PROPOSED RESIDENCE AT:

325 VIA LINDA

ARCOM # ARC-24-074

MAT-O.1

PROPOSED
EAST ELEVATION - GUESTHOUSE

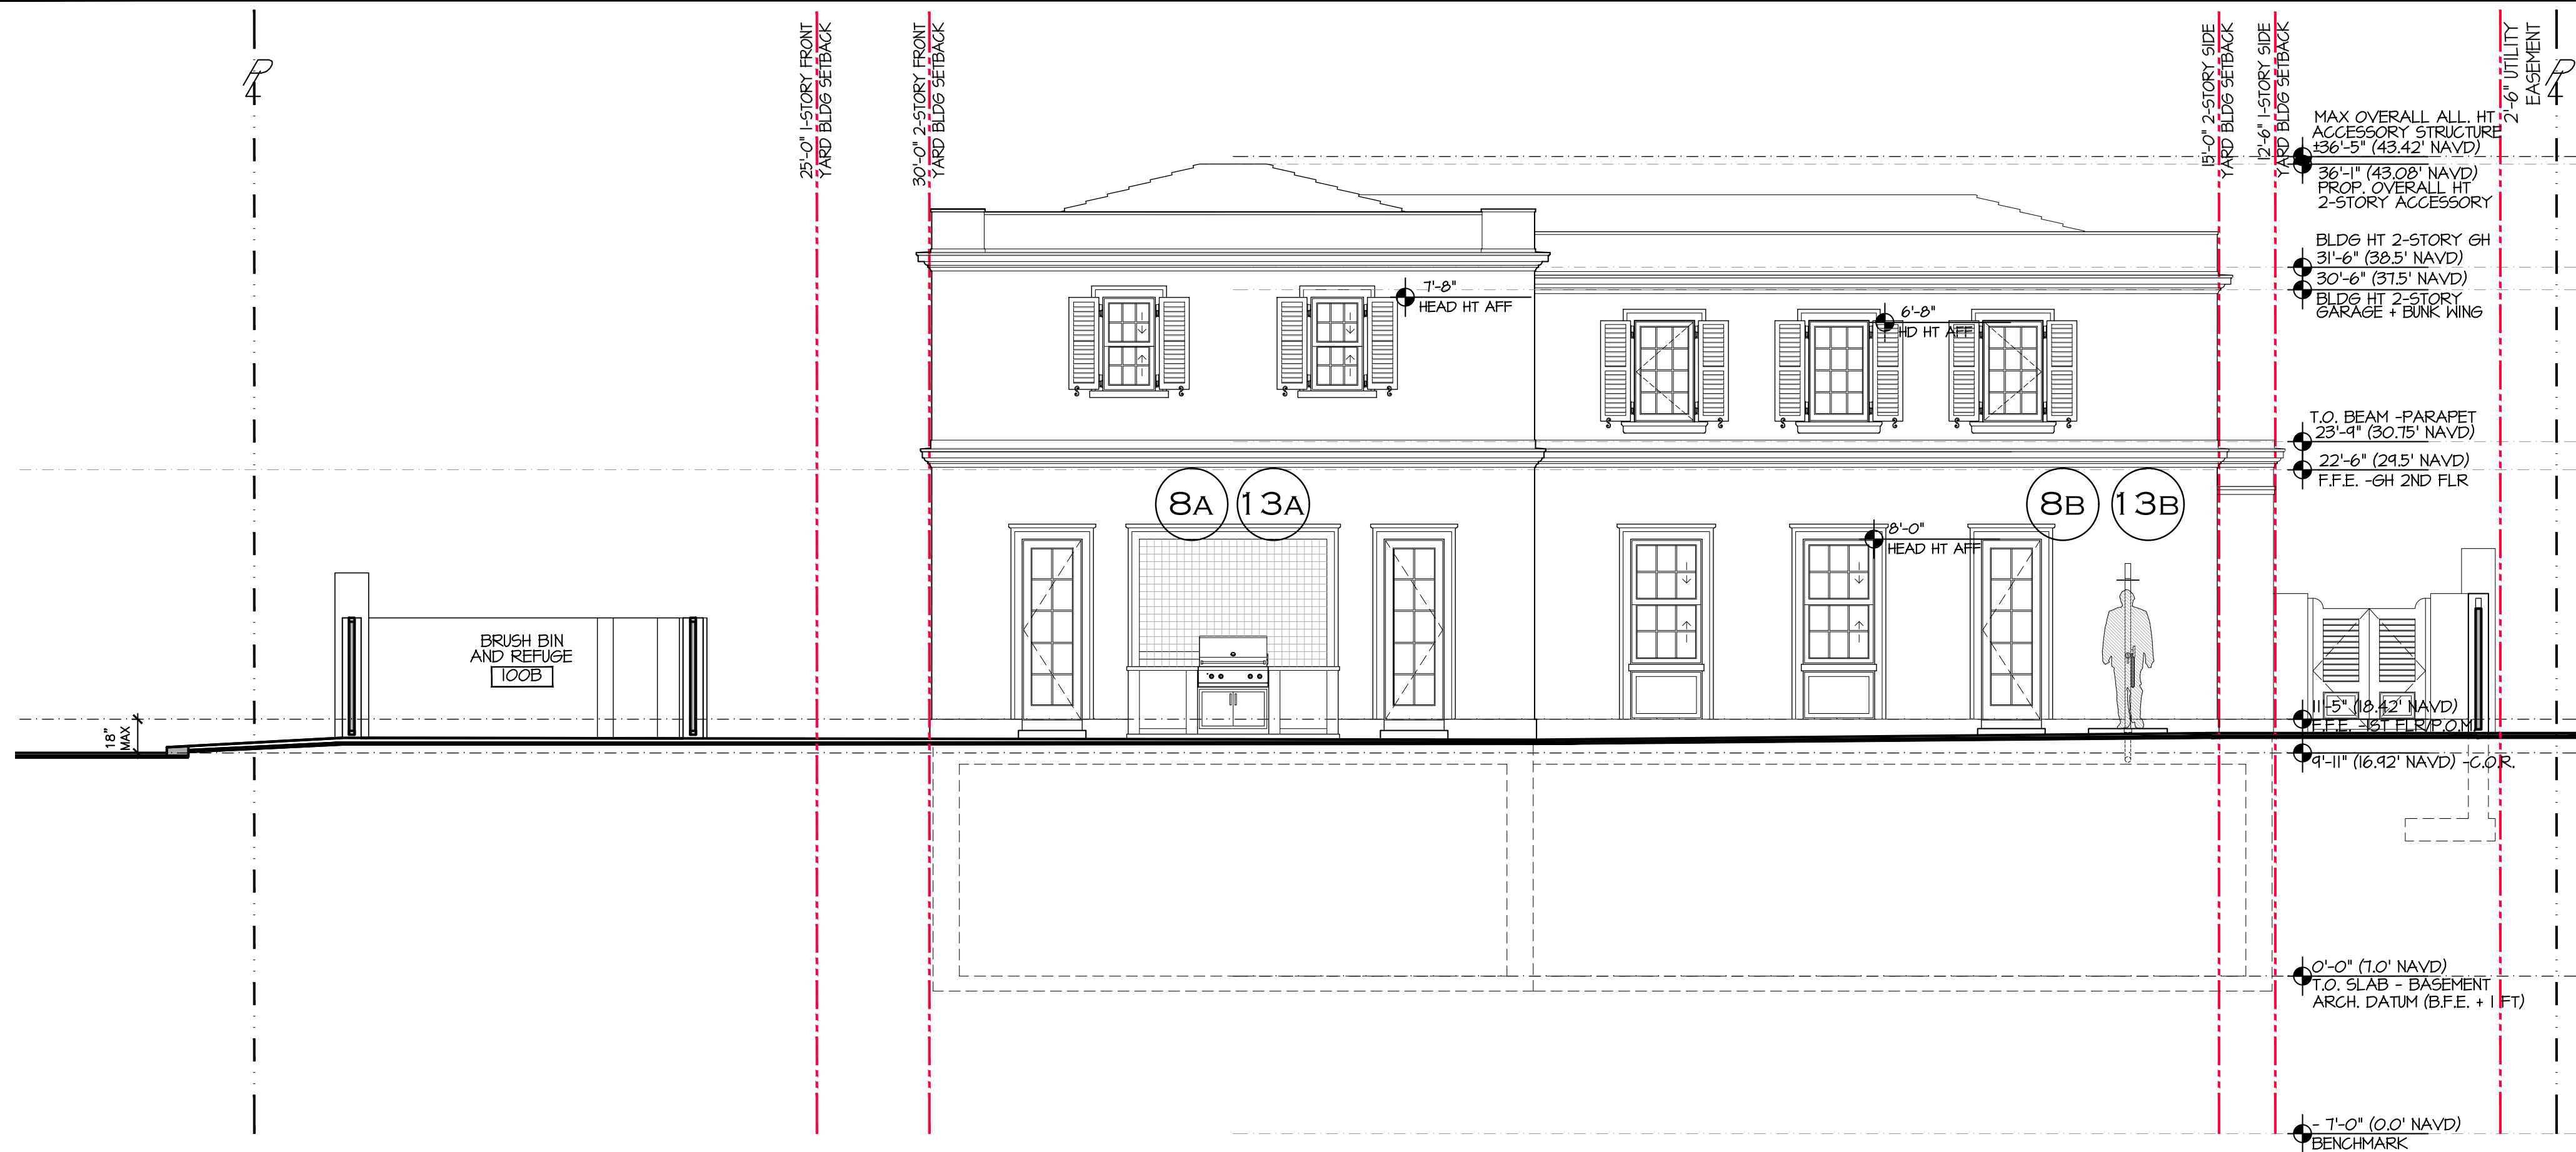
1. TYPICAL DOORS AND WINDOWS REVISED TO IMPACT RATED WOOD FENESTRATIONS, PAINTED WHITE IN LIEU OF BRONZE.

8a. SOUTH END FIRST FLOOR, PROPOSAL TO ELIMINATE THE CENTER WINDOW AND REVISE THE (2) OUTER WINDOWS TO FRENCH DOORS.

8b. NORTH END FIRST FLOOR PROPOSAL TO, REVISE (1) WINDOW TO A FRENCH DOOR.

13a. PROPOSED BBQ GRILL.

13b. PROPOSED OUTDOOR SHOWER.

PROPOSED
B-SECT AT GUEST HOUSE/GARAGE
COV. BREEZEWAY SCALE: N.T.S.

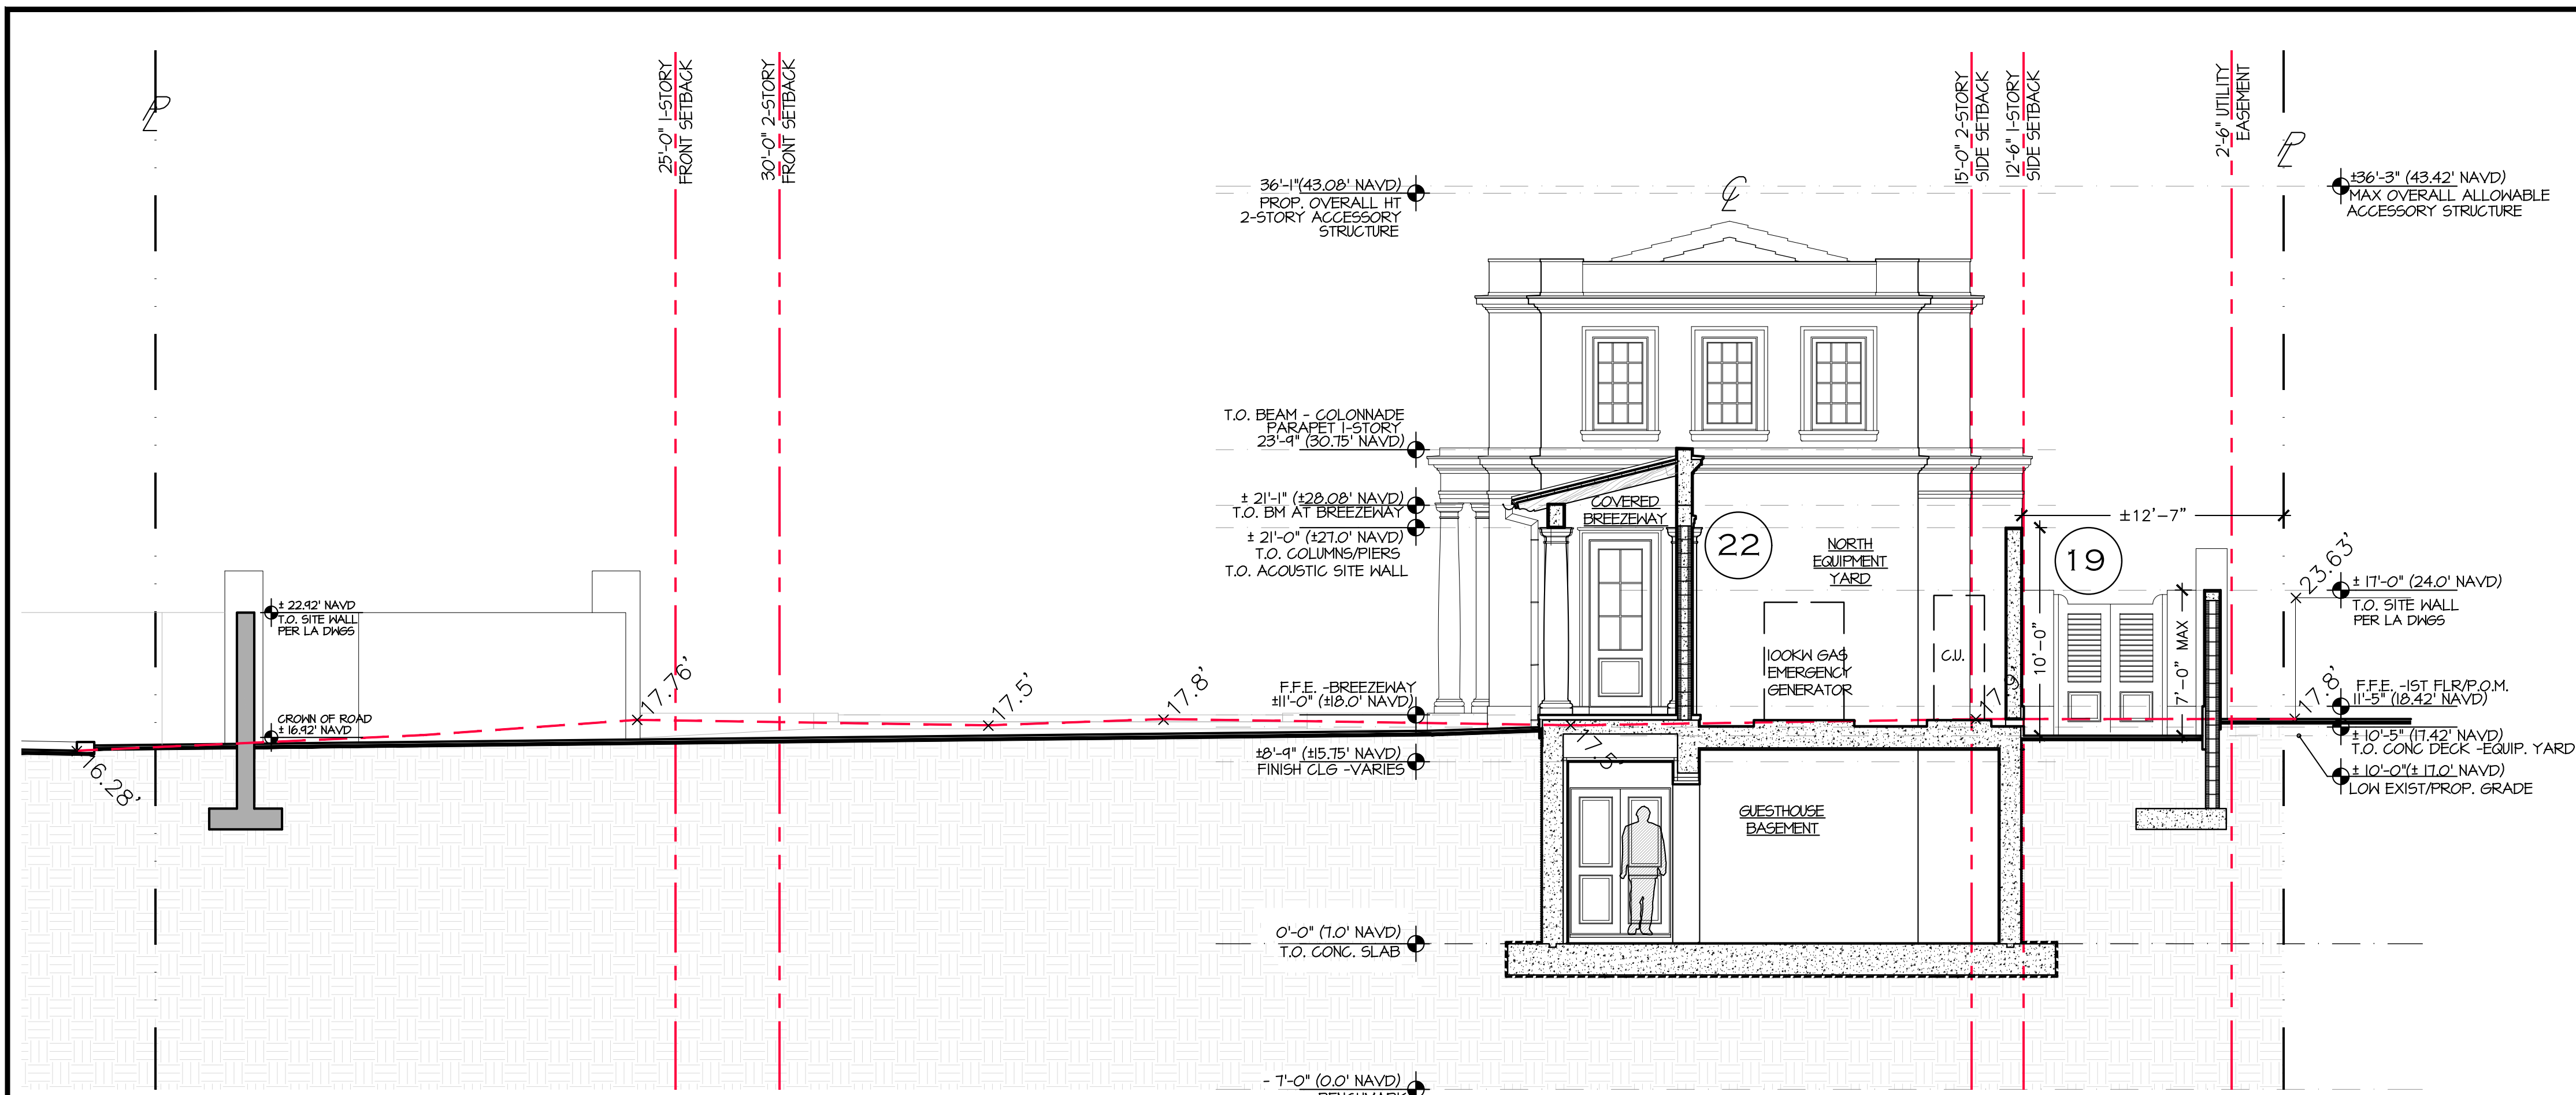
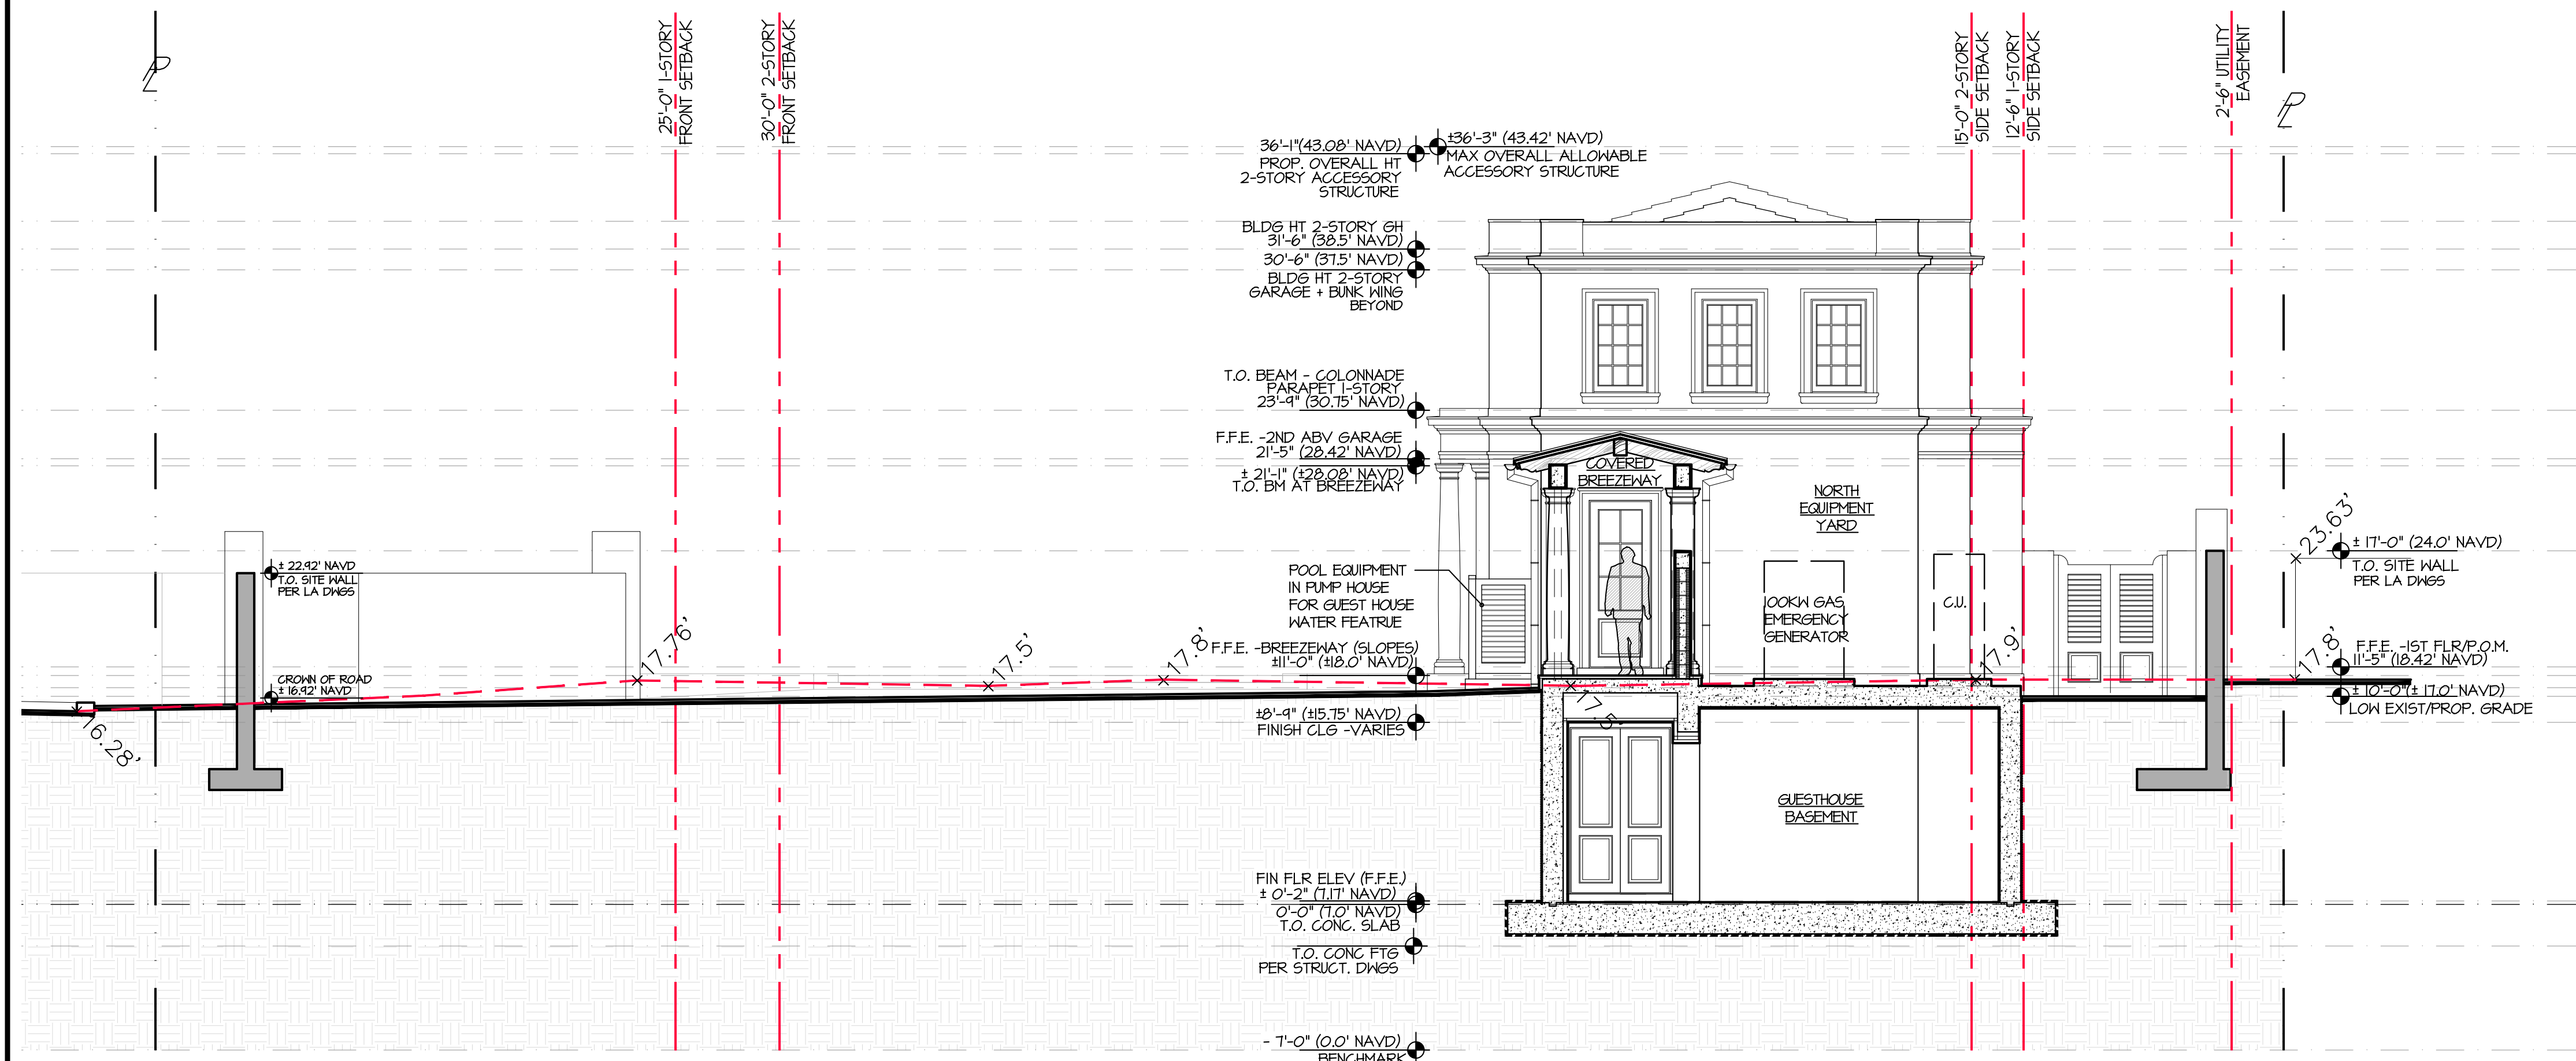
1. TYPICAL DOORS AND WINDOWS REVISED TO IMPACT RATED WOOD FENESTRATIONS, PAINTED WHITE IN LIEU OF BRONZE.

10. RELOCATE WATER FEATURE EQUIPMENT TO NORTH EQUIPMENT YARD, AND REVISE THE WATER FILTRATION AND IRRIGATION BOOSTER & PANEL LOCATION. ALL TO BE WITHIN THE NORTH EQUIPMENT YARD AND SITE WALLS. (REFER TO PLANS FOR LOCATIONS, NOT SHOWN THIS SECTION FOR CLARITY.)

19. PROPOSED SITE WALL WITHIN THE BUILDING SETBACK AT THE NORTH EQUIPMENT YARD, PROVIDING AN ADDITIONAL LAYER FOR ACOUSTICS.

22. COVERED BREEZEWAY AT GUEST HOUSE WITH PROPOSAL FOR SOLID NORTH WALL WITH PARAPET (SEPARATION FROM THE N. EQUIPMENT YARD), WITH ROOF SLOPING TO THE SOUTH IN LIEU OF PREVIOUS HIP.
